Re: Former FF/NN Landfill
WDNR License # 467
BRRTS # 02-20-00915

Re: Response to WDNR Letter and Meeting
FF/NN Landfill, Ripon, WI

FF/NN LANDFILL RIPON, WISCONSIN	DATE: 10/15/03
PROPOSED MONITORING WELLS AND GAS PROBES	DESIGNED: HWY
	CHECKED: HWY
	APPROVED: GLD
	DRAWN: HJW
	PROJ.: 1011.002
 A TETRA TECH COMPANY	Figure 1

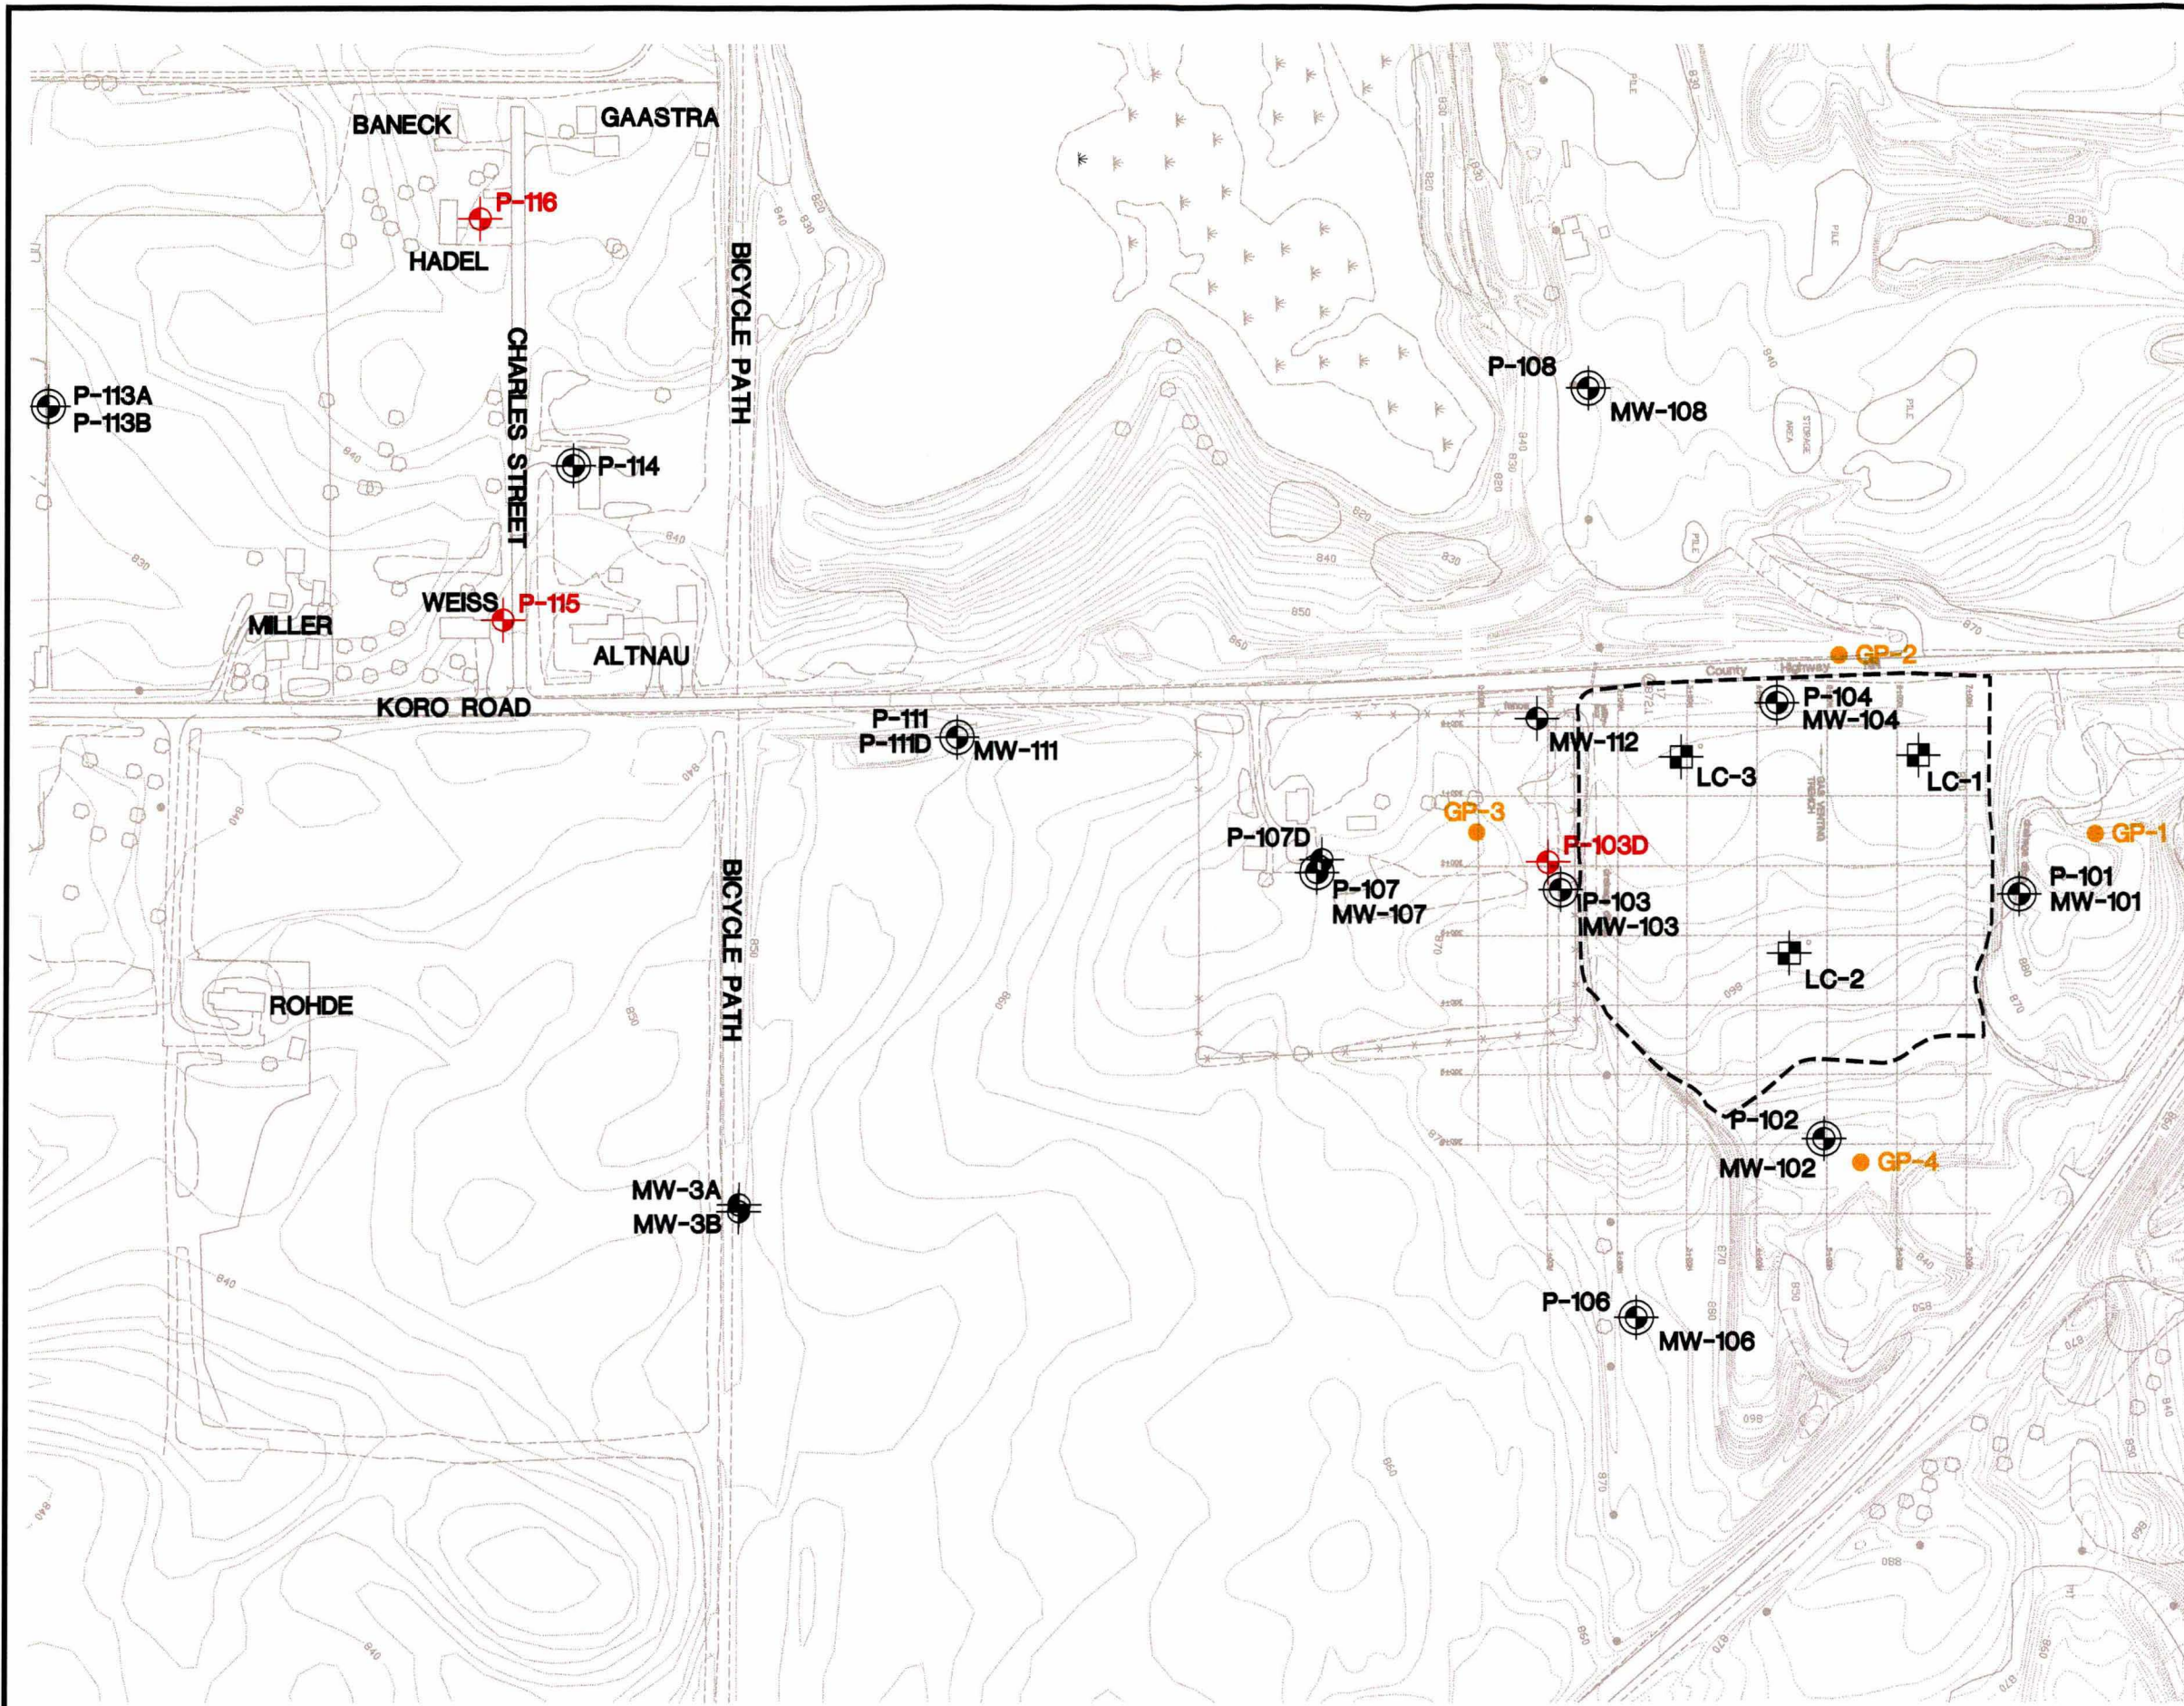
11-11-03
Talked with Jerry DeMers
OK to convert private
wells to MW's.
J. Pelczar

- *Install at least one well between P-114 and the Hadel well to serve as a sentinel well for the downgradient private wells. This well would be screened near the top of the sandstone and must be clean, or an additional well would then need to be installed downgradient of it.*

- *The WDNR requested that four gas probes be installed outside of the landfill boundaries, one in each compass direction. In addition, if monitoring wells are to be used as gas wells, they should be equipped with gas collection shut off valves.*

GeoTrans recommends connecting the Hadel and Weise households to the public water supply and converting their private wells to be used as monitoring wells (P-115 and P-116, Figure 1). Converting these two wells will fulfill two important goals. First, the wells will serve as sentinel wells directly downgradient of the vinyl chloride plume. Second, hooking the homes to public water will eliminate them as potential receptors.

As previously noted we recommend installing four gas probes outside of the landfill boundaries, one in each compass direction. These locations are shown on Figure 1 and placement is dependent on access being authorized by the property owners. Probe GP-2 would be placed in the road right-of-way west of the landfill. The other three probes will be placed 145 feet from the edge of the waste, as allowed by NR 507.11(3)(b).

Each gas probe will be screened from 5 feet below the ground surface to the depth of the waste. Each probe will be provided with a shutoff valve. If property access is not authorized for installation of a particular probe, that gas probe will be placed at the landfill property boundary and outside of the waste boundaries.

RIPON FF/NN LANDFILL RIPON, WISCONSIN		
1991 EXISTING CONDITIONS		
DRAWING: 1511-b3	FIGURE:	RI 2-3

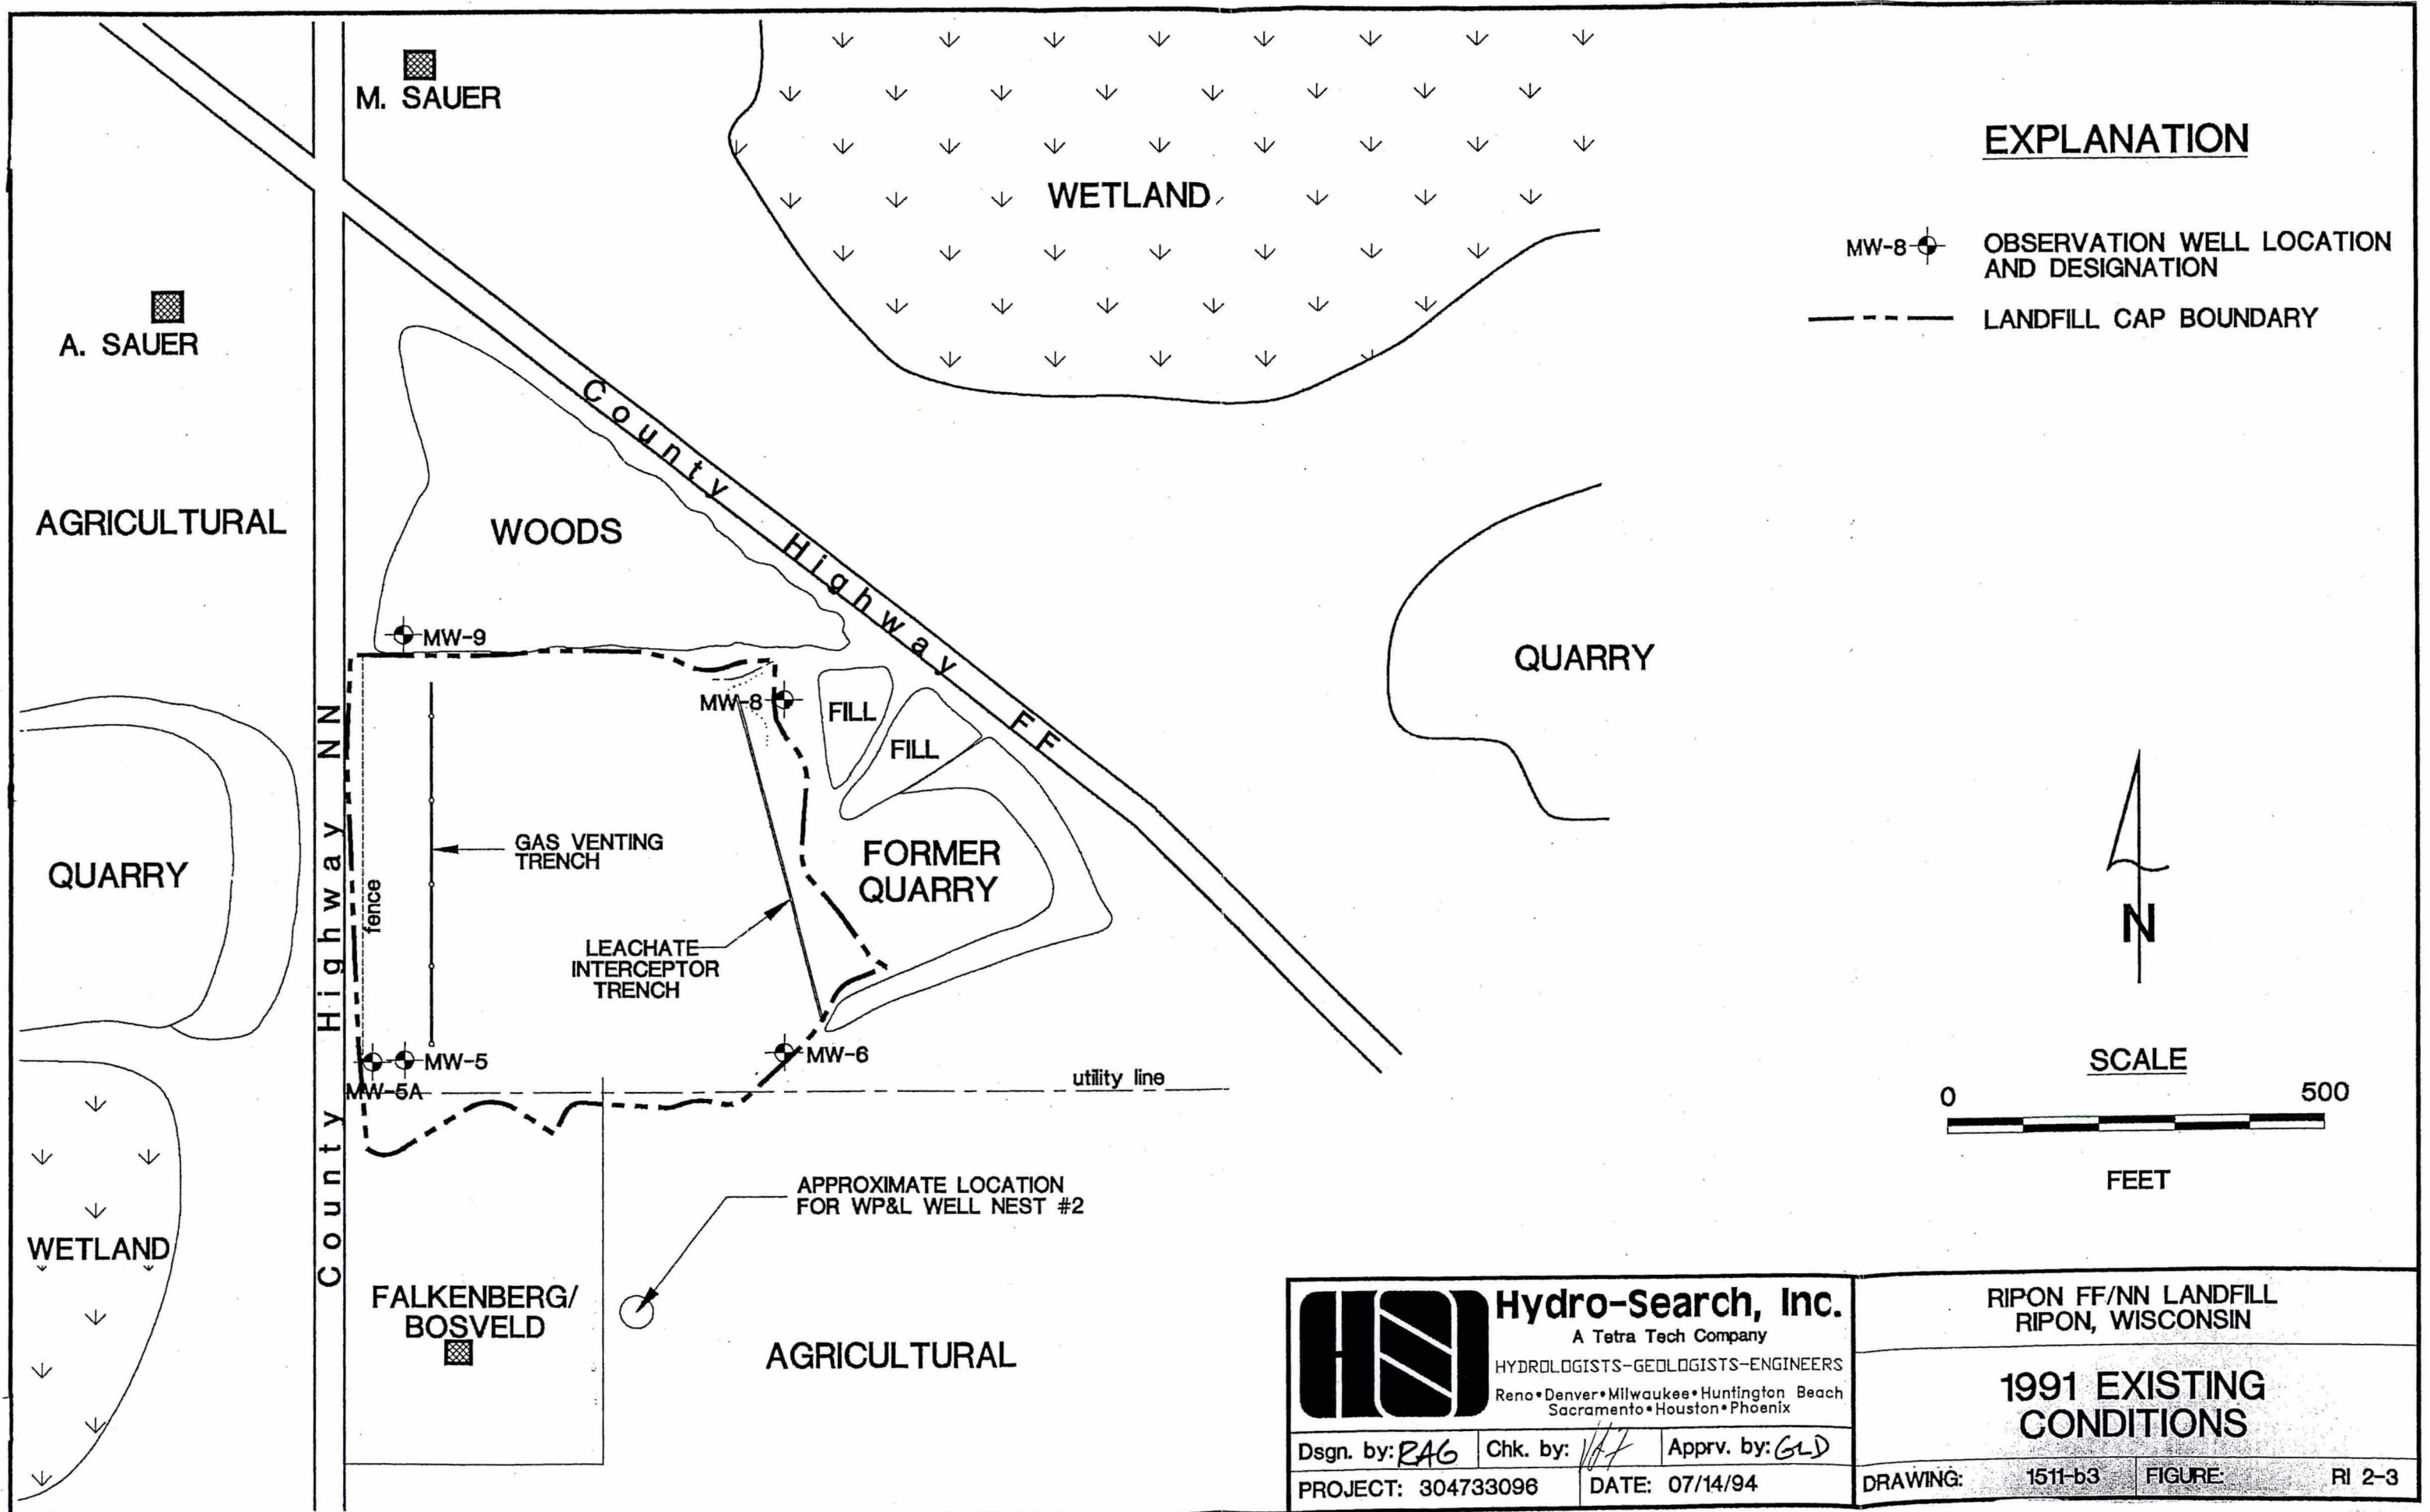
- *Install one well east of well nest 111 that would be screened near the top of the sandstone to evaluate if high concentrations of VOCs are present at depth at that location that are serving as a secondary source for the deeper plume.*

GeoTrans does not believe that additional delineation east of well nest 111 is necessary. There is historical data from several WP&L wells showing that the centerline of the vinyl chloride plume is traveling directly south from the landfill. During the remedial investigation, vertical profiling results showed that the Bosveld well and P-107D had concentrations ranging from 5 to 48 ppb. However, concentrations from WP&L well nest #2, located east of the Bosveld property and southeast of the landfill, showed that concentrations ranged from non-detect to 4.2 ppb. This would indicate that the area southeast of the landfill is on the periphery of the vinyl chloride plume. Current monitoring data confirm this pattern with well P-111D having concentrations ranging from 11-15 ppb yet wells MW-3A and 3B have no detections of vinyl chloride.

The WP&L MW-2 nest location was close to that requested by the WDNR, and its wells were screened at 180, 200 and 280 feet deep. Additional well information is attached. These wells were abandoned prior to the 1994 Remedial Investigation.
